TRANS/WP.29/683  
23 July 1999

Working Party on the Construction of Vehicles

DRAFT 03 SERIES OF AMENDMENTS TO REGULATION No. 41

(Noise of motorcycles)

Figure 1

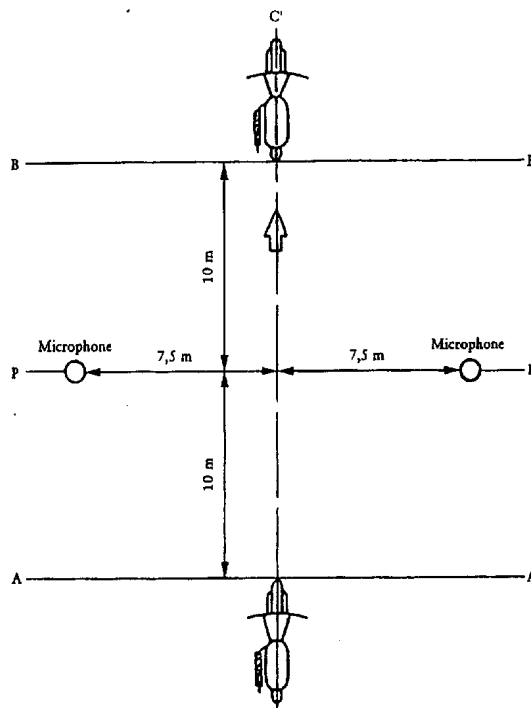
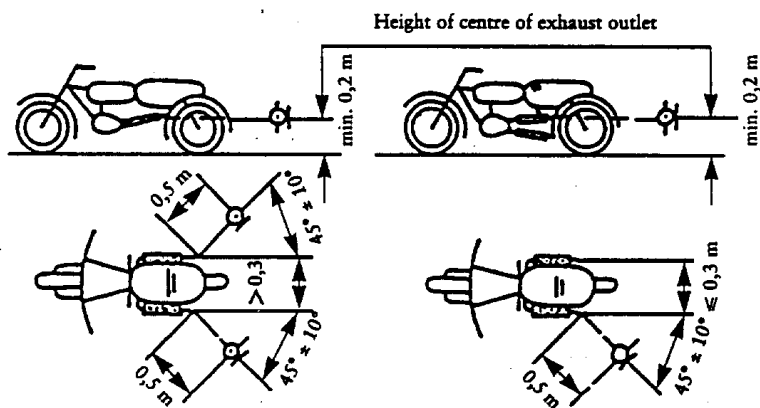
The maximum sound level expressed in A-weighted decibels (dB(A)) shall be measured as the motorcycle travels between lines AA' and BB' (figure 1). The measurement will be invalid if an abnormal discrepancy between the peak value and the general sound level is recorded.

The microphone shall be located  $7,5 \text{ m} \pm 0,2 \text{ m}$  from the reference line CC (see appendix - Figure 1) of the track and  $1.2 \text{ m} \pm 0,1 \text{ m}$  above ground level.

The motorcycle shall approach line AA' at an initial steady speed as specified in 1.4.3.1 and 1.4.3.2. When the front of the motorcycle reaches line AA' the throttle shall be fully opened as quickly as practically possible and kept in that position until the rear of the motorcycle reaches line BB'; the throttle must then be returned as quickly as possible to the idle position.

Figure 2

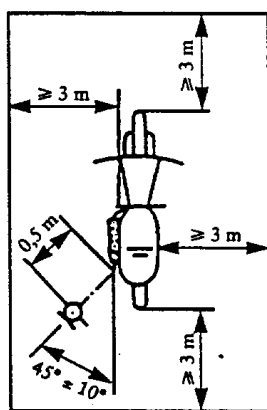
2.4.2. Positioning of the microphone (See appendix - figure 2)

The microphone shall be positioned level with the exhaust outlet or 0.2 m above the surface of the track, whichever is the highest. The microphone diaphragm shall face towards the exhaust outlet at a distance of 0.5 m from it. The axis of maximum sensitivity of the microphone shall be parallel to the surface of the track at an angle of  $45^{\circ} \pm 10'$  to the vertical plane of the direction of the exhaust emissions.

Figure 1: Minimum requirements for test surface area. The shaded part is called "Test Area".

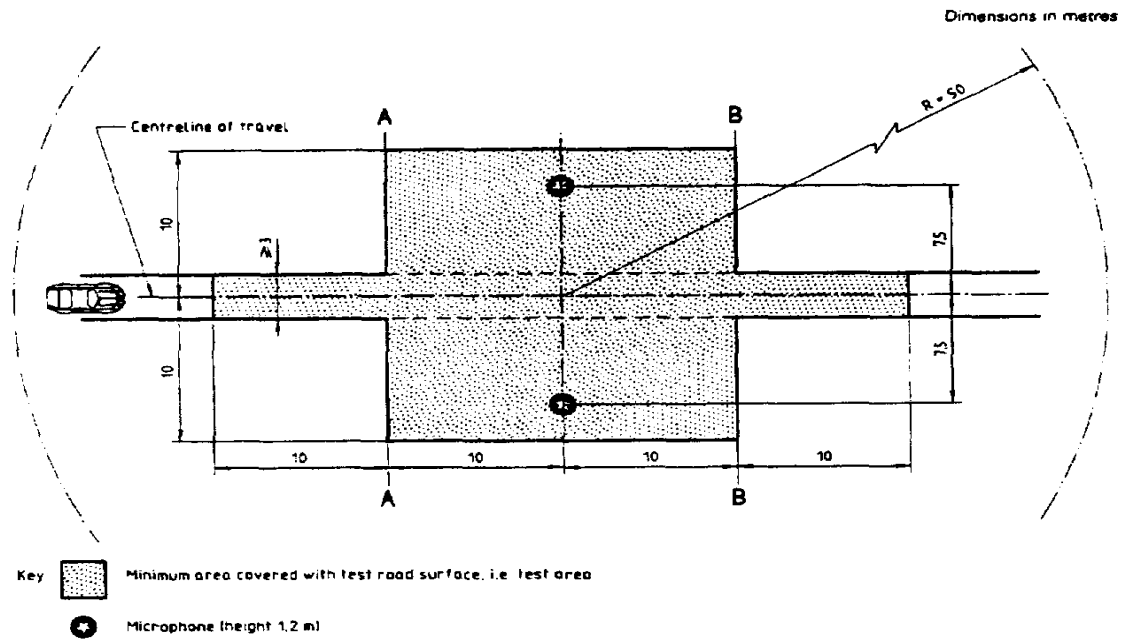
When designing the test track layout it is important to ensure that, as a minimum requirement, the area traversed by the vehicles running through the test strip is covered with the specified test material with suitable margins for safe and practical driving. This will require that the width of the track is at least 3 m and the length of the track extends beyond lines AA and BB by at least 10 m at either end. Figure 1 shows a plan of a suitable test site and indicates the minimum area which shall be machine laid and machine compacted with the specified test surface material. According to annex 3, paragraph 3.1.1.1., measurements have to be made on each side of the vehicle. This can be made either by measuring with two microphone locations (one on each side of the track) and driving in one direction, or measuring with a microphone only on one side of the track but driving the vehicle in two directions. If the former method is used, then there are no surface requirements on that side of the track where there is no microphone.

If it is necessary to repave the test track, it is usually unnecessary to repave more than the test strip (of 3 m width in Figure 1) where vehicles are driving, provided the test area outside the strip met the requirement of residual voids content or sound absorption when it was measured.

Figure 2: Grading curve of the aggregate in the asphaltic mix with tolerances.

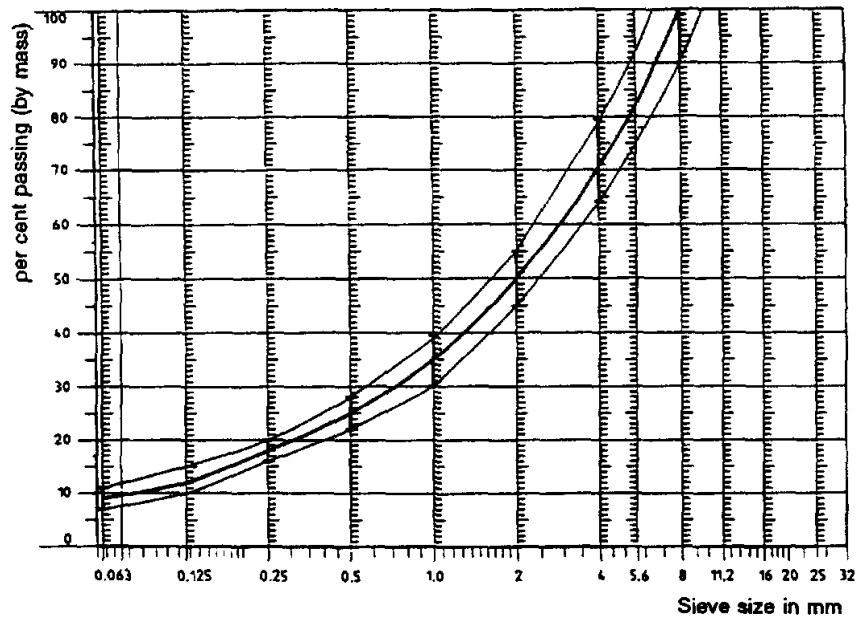
As a guide to the surface constructor, an aggregate grading curve which will give desired characteristics is shown in Figure 2. In addition, Table 1 gives some guidelines in order to obtain the desired texture and durability. The grading curve fits the following formula:

$$P (\% \text{ passing}) = 100 \cdot (d/d_{\max})^{1/2}$$
